**City of Pembroke Pines**  
**Planning & Economic Development Department**  
**601 City Center Way 3<sup>rd</sup> Floor**  
**Pembroke Pines FL, 33025**

<b>Agenda Date:</b>	September 11, 2025	<b>Application ID:</b>	SP2025-0001
<b>Project:</b>	Chabad of Pembroke Pines Mikveh	<b>Project Number:</b>	PRJ2025-0002
<b>Project Planner</b>	Cole Williams, Senior Planner		
<b>Owner:</b>	Chabad Lubavitch of Pembroke Pines INC	<b>Agent:</b>	Jeremy Shir
<b>Location:</b>	18490 Johnson Street	<b>Commission District</b>	4
<b>Existing Zoning:</b>	PUD (Planned Unit Development)	<b>Existing Land Use:</b>	Commercial
<b>Reference Applications:</b>	SUBDR2025-0001, ZV2025-0010		
<b>Applicant Request:</b>	Construct a free-standing Mikveh.		
<b>Staff Recommendation:</b>	Approval subject to the recordation of the underlying plat		
<b>Final:</b>	<input checked="" type="checkbox"/> Planning & Zoning Board <input type="checkbox"/> City Commission		
<b>Reviewed for the Agenda:</b>	Director:  Assistant Director:

Jeremy Shir, agent, requests approval to construct a free-standing Mikveh with associated site, signage, lighting and landscape modifications for the Chabad of Pembroke Pines located at 18490 Johnson

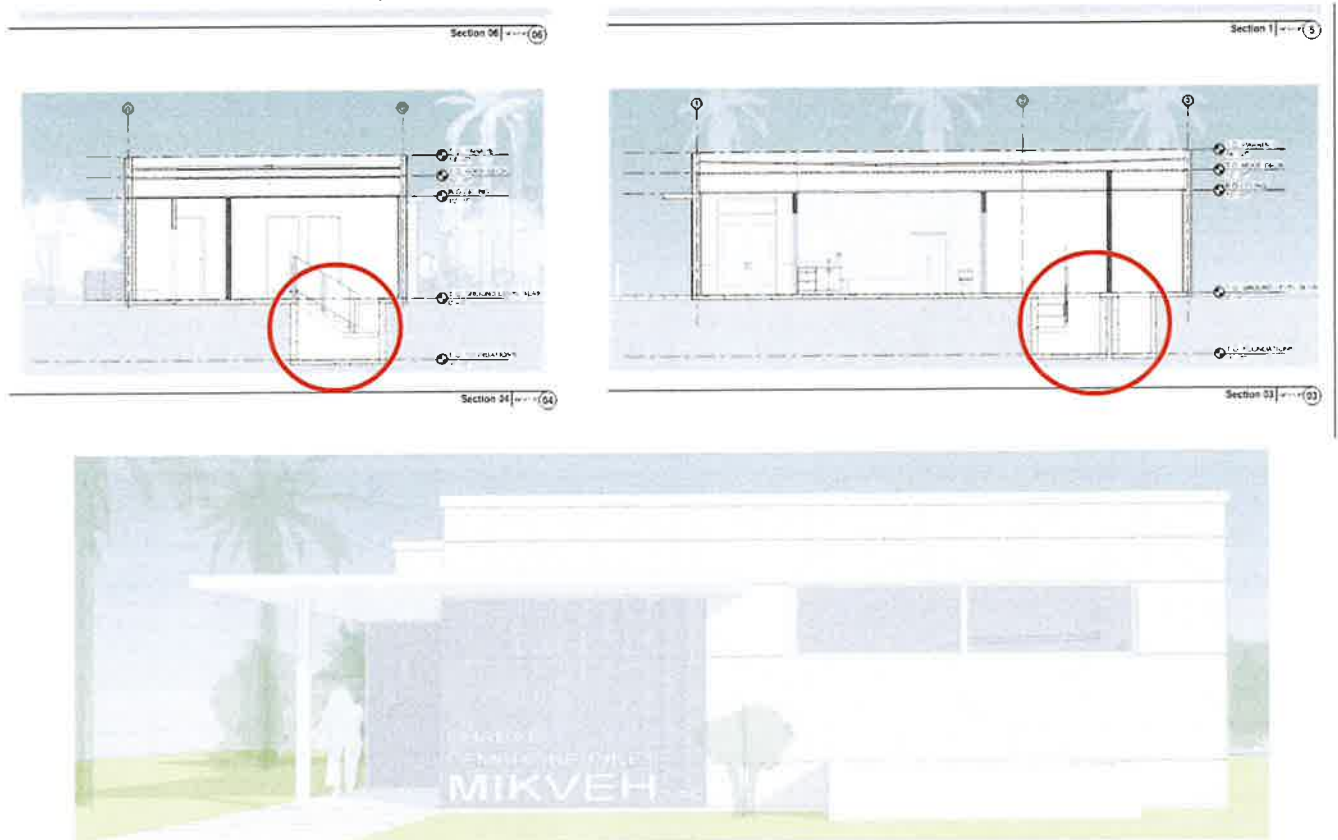
3. What is the intent of this area? Provide more information to clarify if the intention is truly to go six feet below ground. There seems to be a misunderstanding on the datum being used, it is difficult to go deep below ground without running into the water table in Florida. All the buildings in the area are elevated, using stairs and ramps for access. Clarify if the building will be flushed to the ground level.

PAVING, GRADING, & DRAINAGE PLAN  
FOR  
**PROPOSED MIKVEH AT**  
CHABAD OF PEMBROKE PINES  
18490 JOHNSON STREET, PEMBROKE PINES, FL

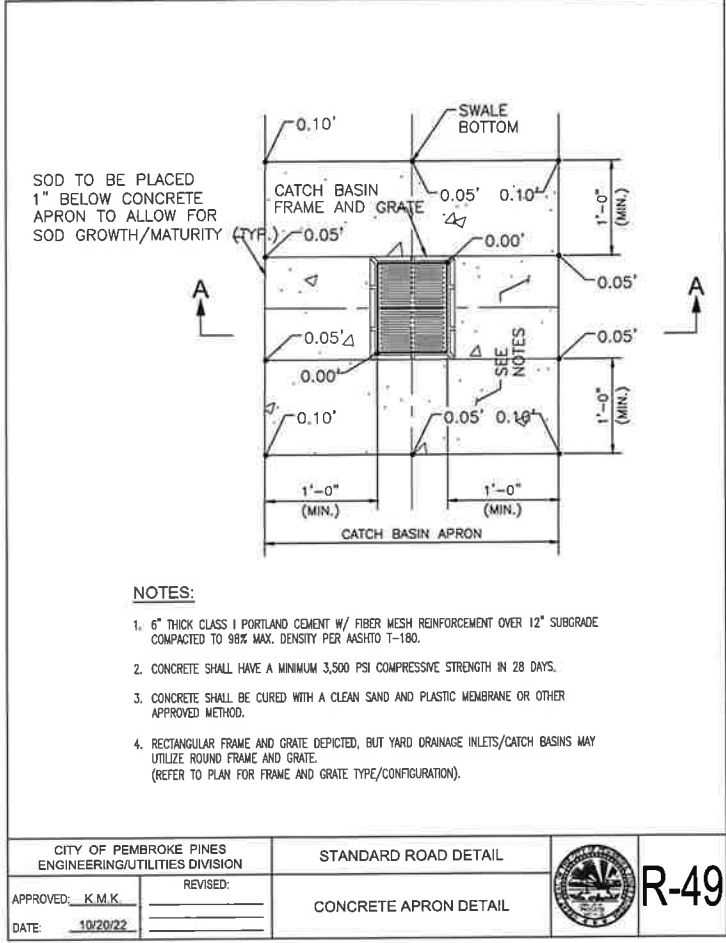
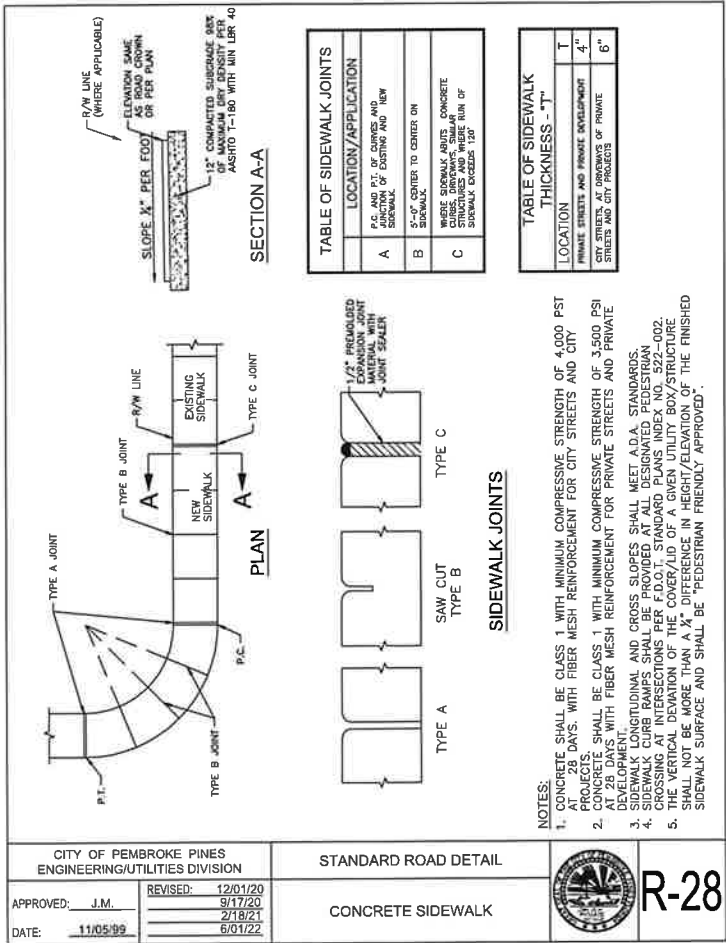
6. Rename the sheet to "Grading & Drainage Plan".
7. Provide proposed and existing elevation spots to show how the proposed building will affect the existing topography of the site. The proposed elevations should include elevation spots around the building showing how the runoff will get to the proposed drainage structure and the dry retention area.
8. Provide the finished floor elevation of the building using the required topographical survey as mentioned in the general comments above (comment #3). See City Ordinance referenced below:

9. Include the dry retention area in the plans showing how the proposed grading will modify the dry retention area.
10. Verify that the drainage structure in the dry retention area labeled as existing yard drain is not actually an existing drainage inlet.

11. The proposed 24" ADS Nyloplast Yard Drain must have a concrete apron on it. See City Detail R-49 and plan mark-ups for reference.
12. The proposed 24" ADS Nyloplast Yard Drain must have a minimum of 12" of slump.

13. Provide the slopes and inverts for all the proposed 6" drainage PVC pipes.
14. Provide elevations for the proposed sidewalk to verify ADA compliance. Include existing elevations to the existing sidewalk and the finished floor elevation to verify that the sidewalk connection will be flush.

15. Proposed sidewalk to follow City Detail R-28 and include the detail to the set.
16. Provide proposed elevations and limits for the enclosed sand playground since it needs to be modified to incorporate the proposed building.

17. There are two dark grey concrete hatches on the north and west side of the proposed building, it is not called out in the legend nor on the plans. Clarify what these areas are and add it to the legend.

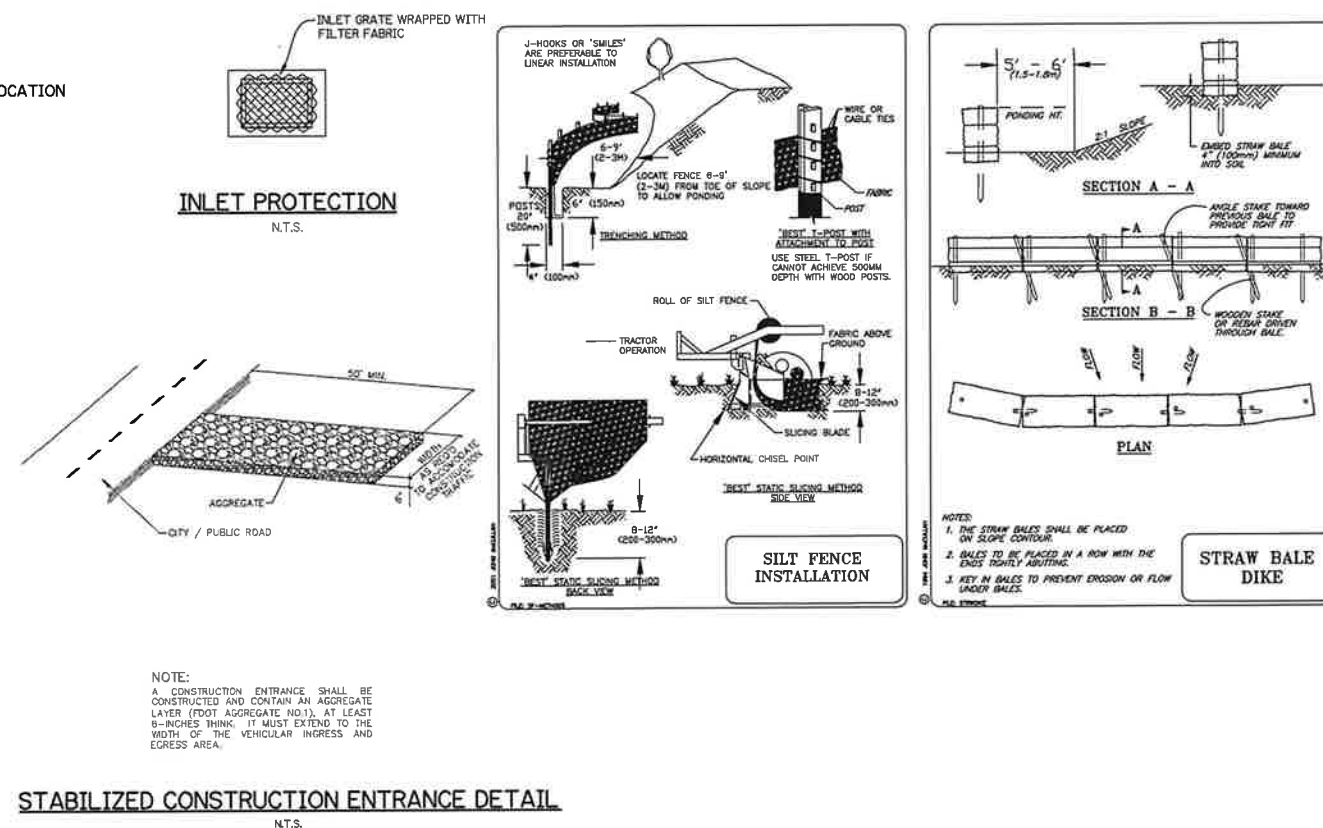
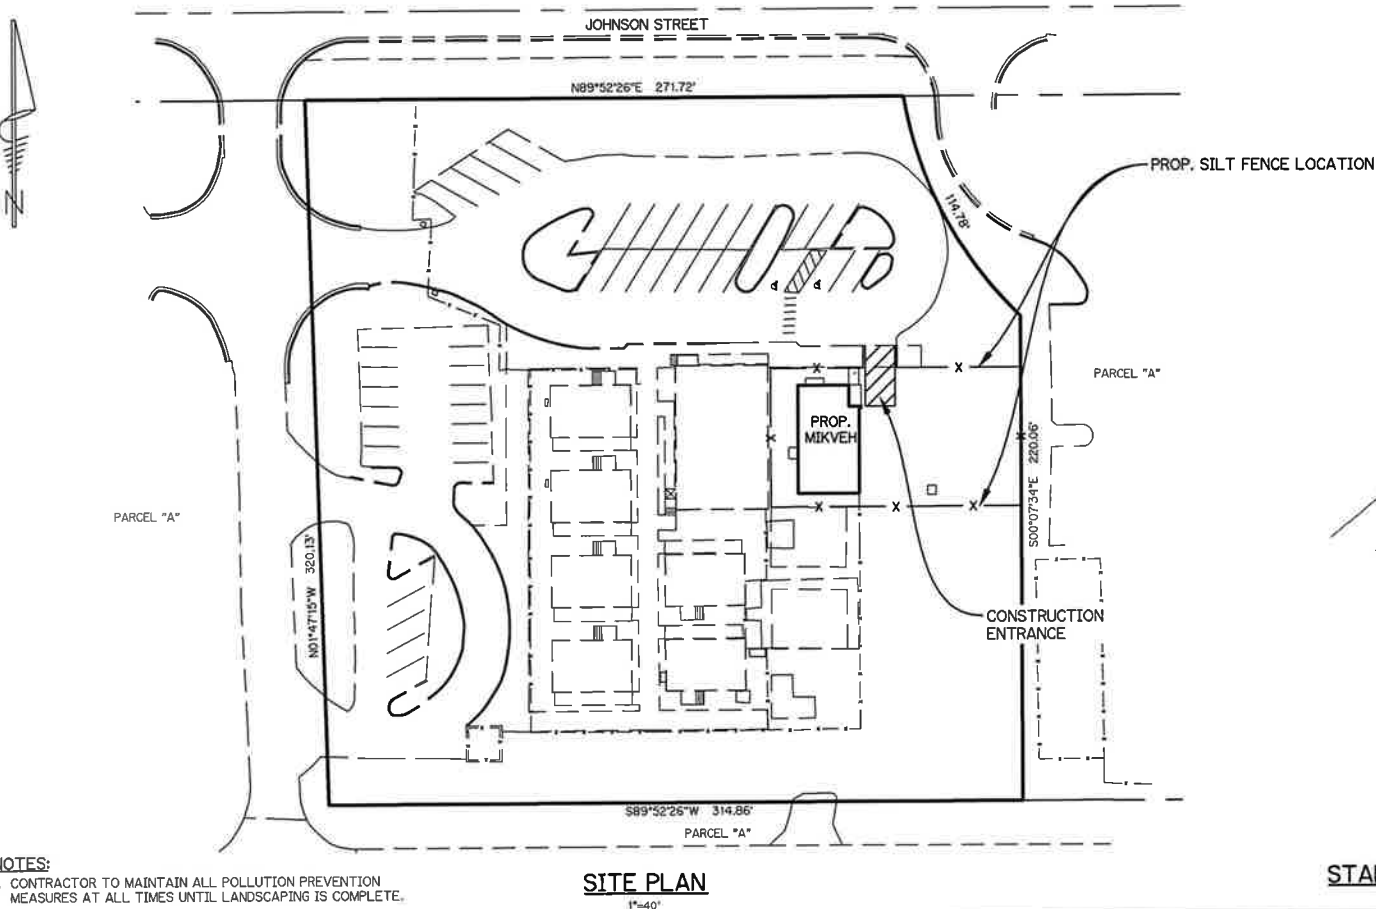
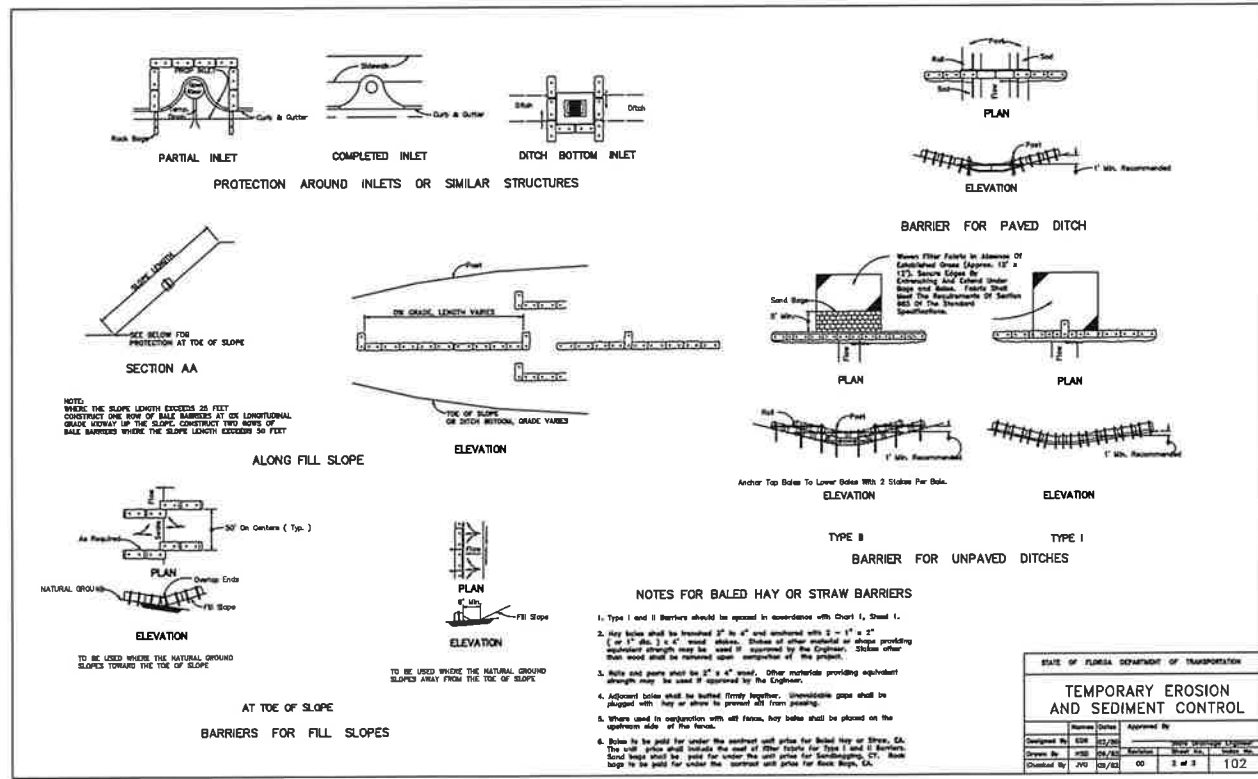
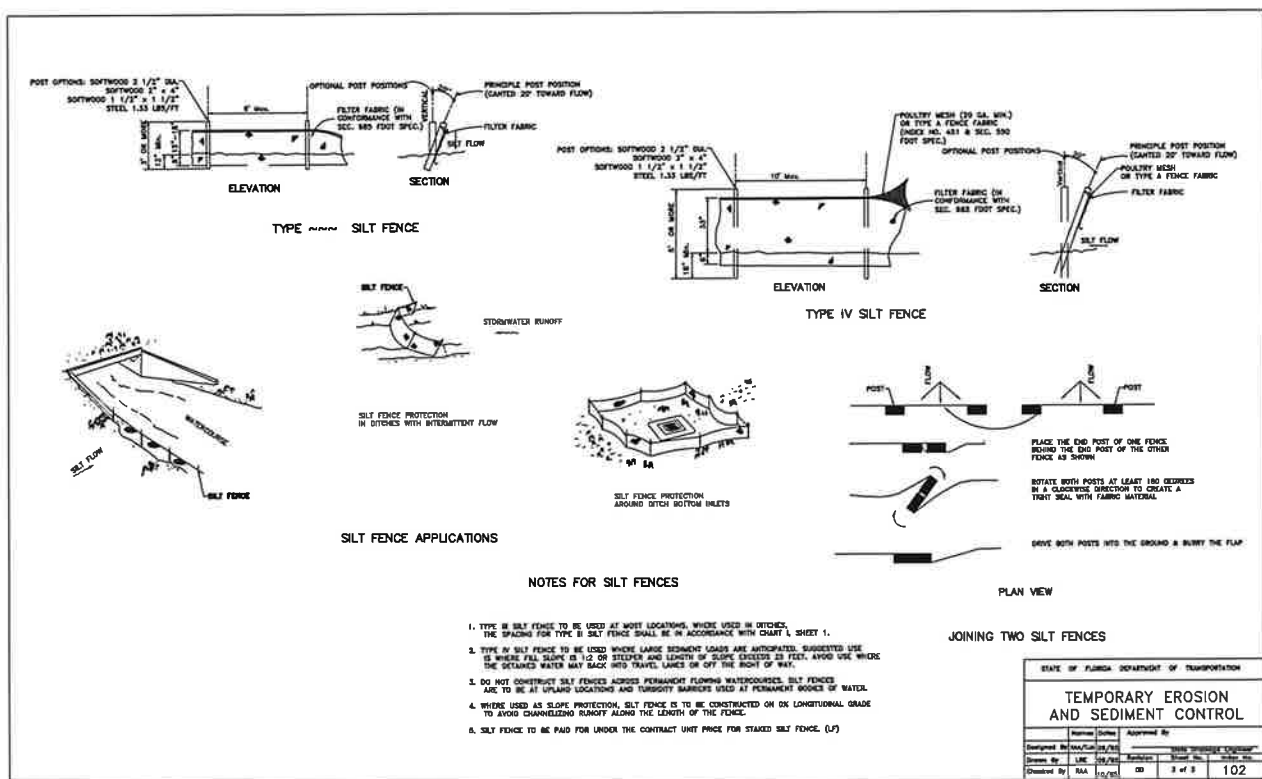
27. It is up to the Engineer of Record (EOR) to determine the exact location, outlines, and devices for pollution prevention measures. This cannot be left up to the contractor.
28. The proposed silt fence outline encloses an existing trailer building and part of the existing sand pit playground. Is the intent to shut these two locations down during construction? If so, the playground might have to be enclosed around the entire perimeter.
29. There is a detail for a construction entrance and the legend calls out for one, but there is no construction entrance on the plans. Include the location of the construction entrance.
30. Call out the existing inlets to be protected during construction, there are two in the dry retention area that need to be protected.
31. Show the entire dry retention area in the plans.
